Addenda No. 2

SUBJECT: I-5: S WOLF CREEK – FOOTHILLS BLVD – BUNDLE 303
PACIFIC HIGHWAY
JOSEPHINE COUNTY
GRADING, DRAINAGE, PAVING AND STRUCTURES
(Bids to be opened and read February 15, 2007)

The following changes are made to the Project Bid Booklet:

SHEET NO.
3

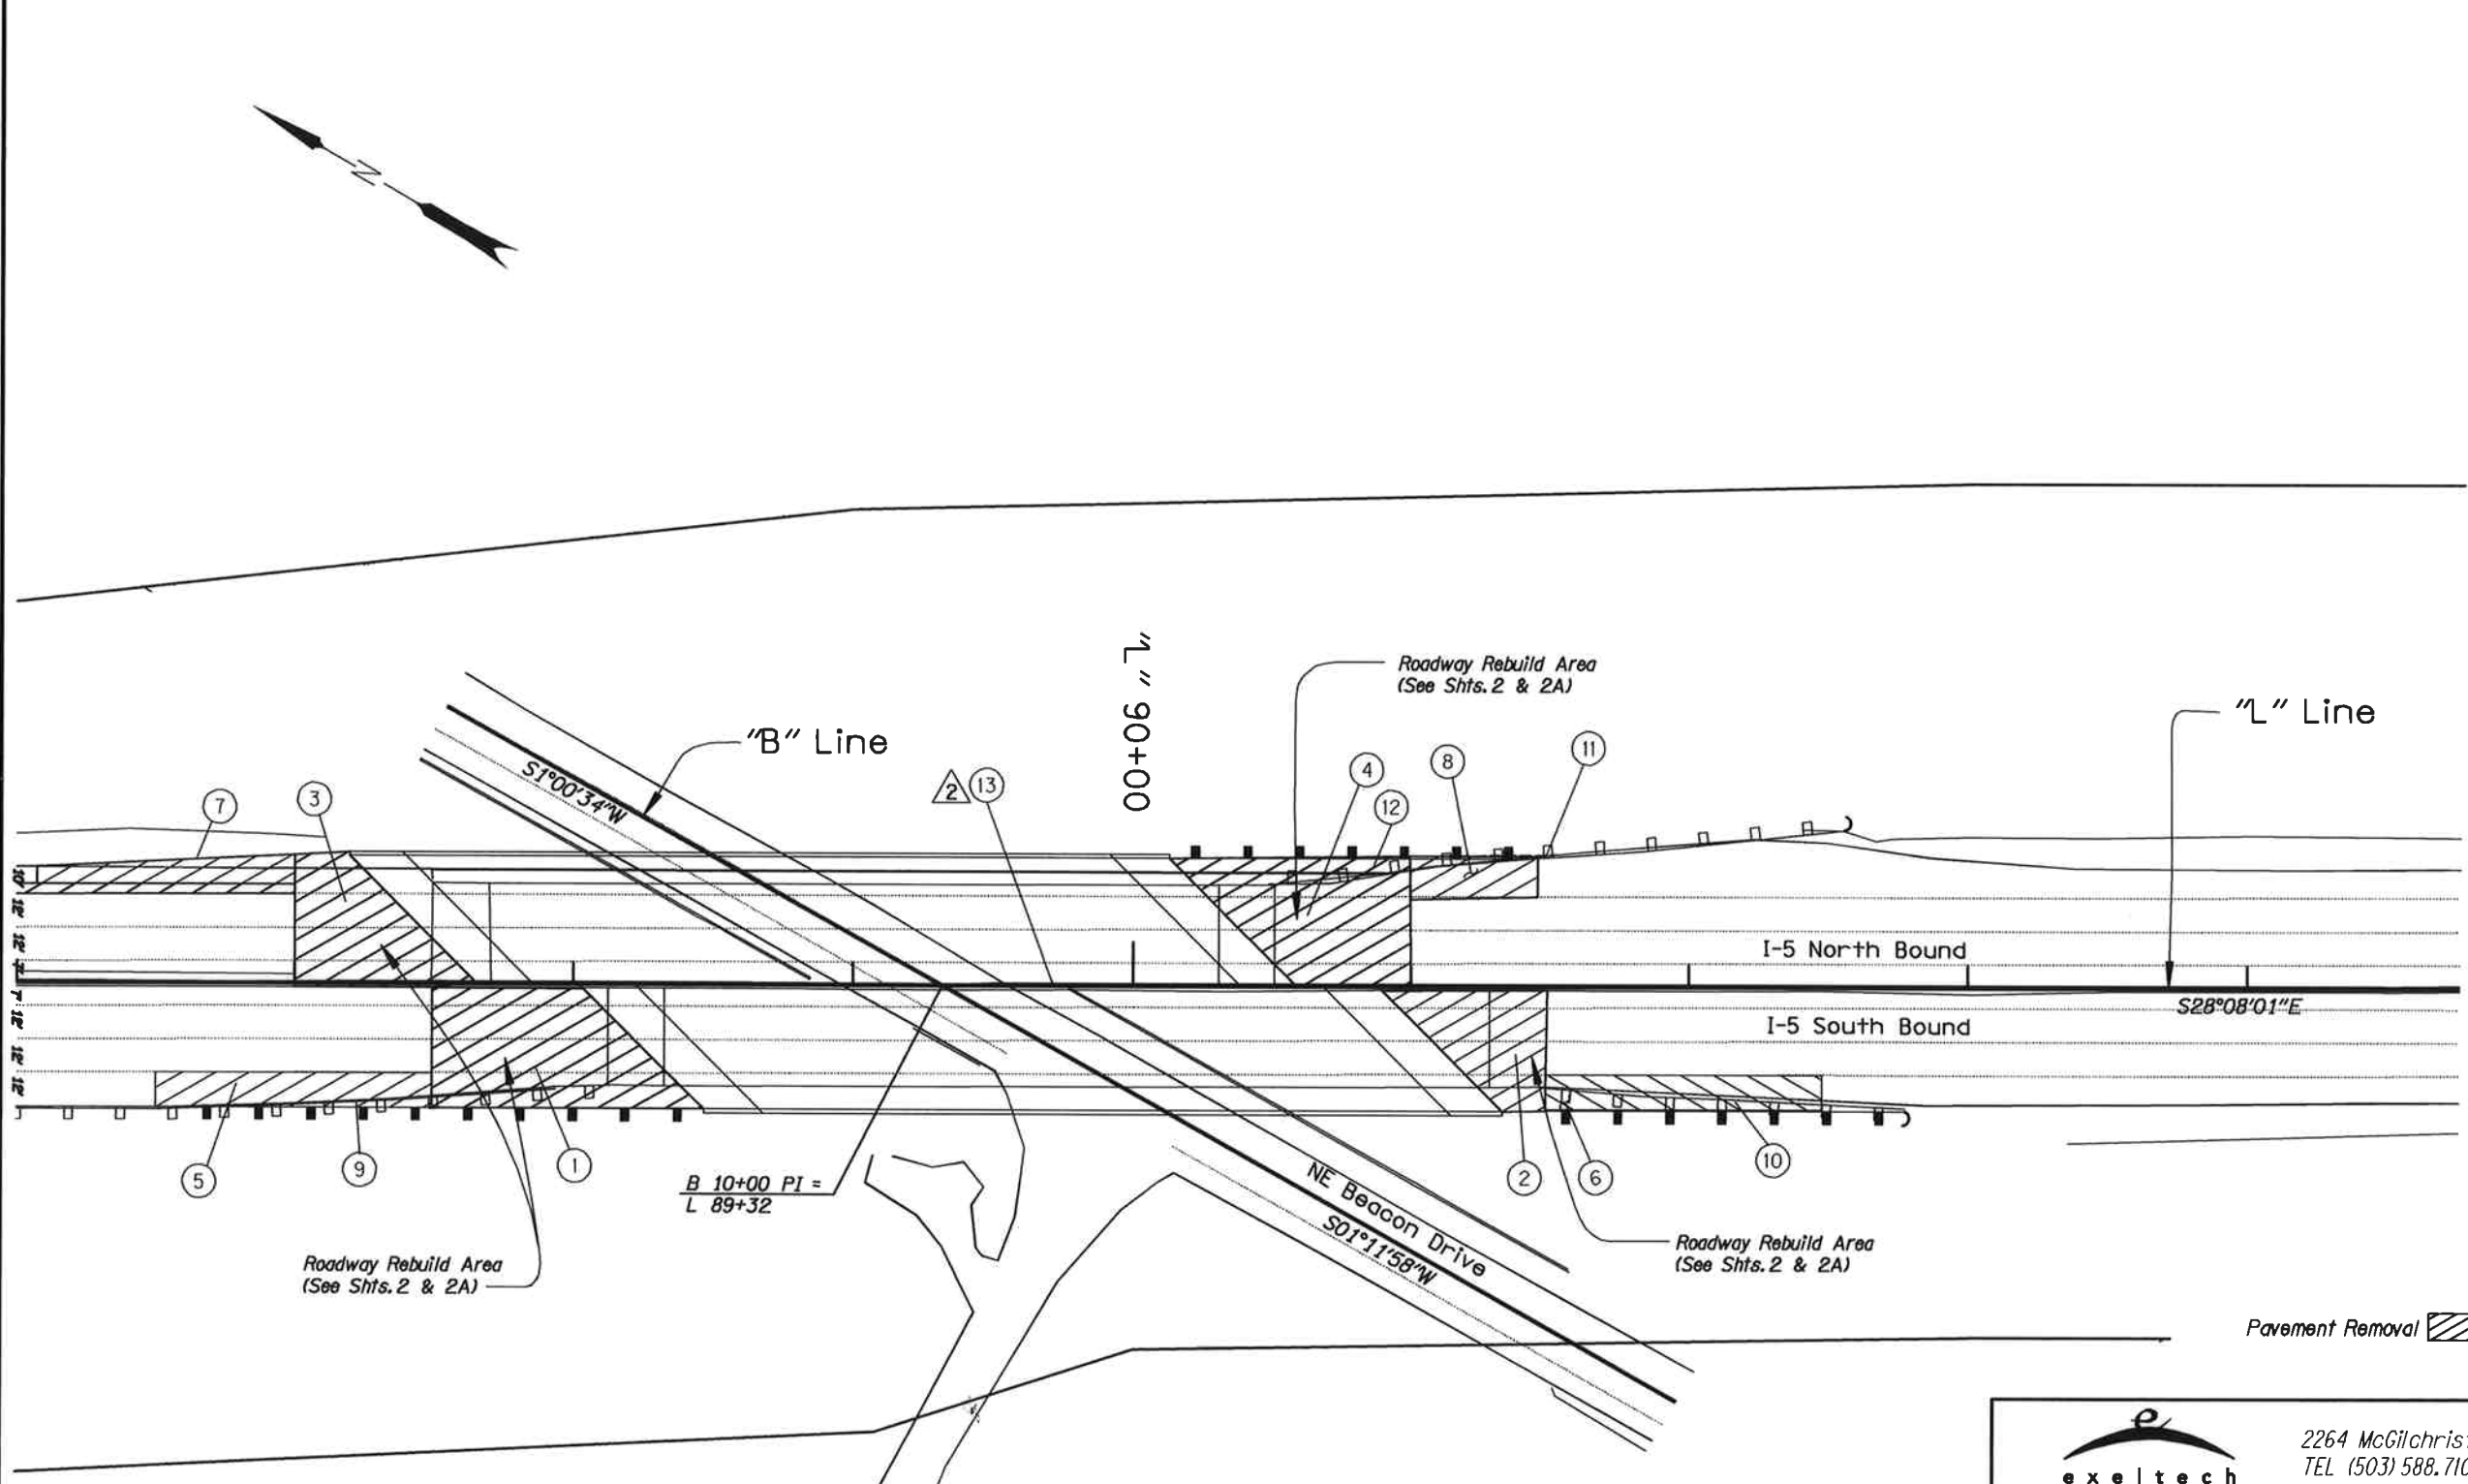
1. Plan sheet 3 is replaced with revised plan sheet 3.

- ⑨ Sta. "L" 86+50 to Sta. "L" 88+50, Rt. Remove Extg. Guardrail - 160' Const. Guardrail - 12.5' (Type 3) - 175' (Type 2A) ^③
Flare Rate = 0
Connect to Extg. Guardrail (See Drg. Nos. RD400, RD405, RD415)
Connect to Permanent Bridge Rail (See Drg. Nos. BR203 and RD440) ^{① ③}

- ⑩ Sta. "L" 91+30 to Sta. "L" 92+80 Remove Extg. Guardrail - 130' Const. Type 2A Guardrail - 150' Const. Guardrail Anchor, Type 1 Modified ^③
Type B End Piece
Connect to Permanent Bridge Rail with Guardrail Connection (See Drg. Nos. BR236, RD415, RD440, and RD450) ^{① ③}

- ⑫ Sta. "L" 90+10 to Sta. "L" 91+50 Remove Temp. Guardrail - 120' Const. Guardrail - 12.5' (Type 3) - 112.5' (Type 2A) ^③
Connect to Extg. Guardrail
Connect to Permanent Bridge Rail (See Drg. Nos. BR203 and RD440) ^{① ③}
- ⑬ Sta. "L" 79+00 to Sta. "L" 100+00 Const. Conc. Median Barrier - 2100'

REVISIONS	
①	Revised 01-14-2007 Revised Note
②	Revised 01-14-2007 Added Callout
③	Revised 02-08-2007 Revised Note
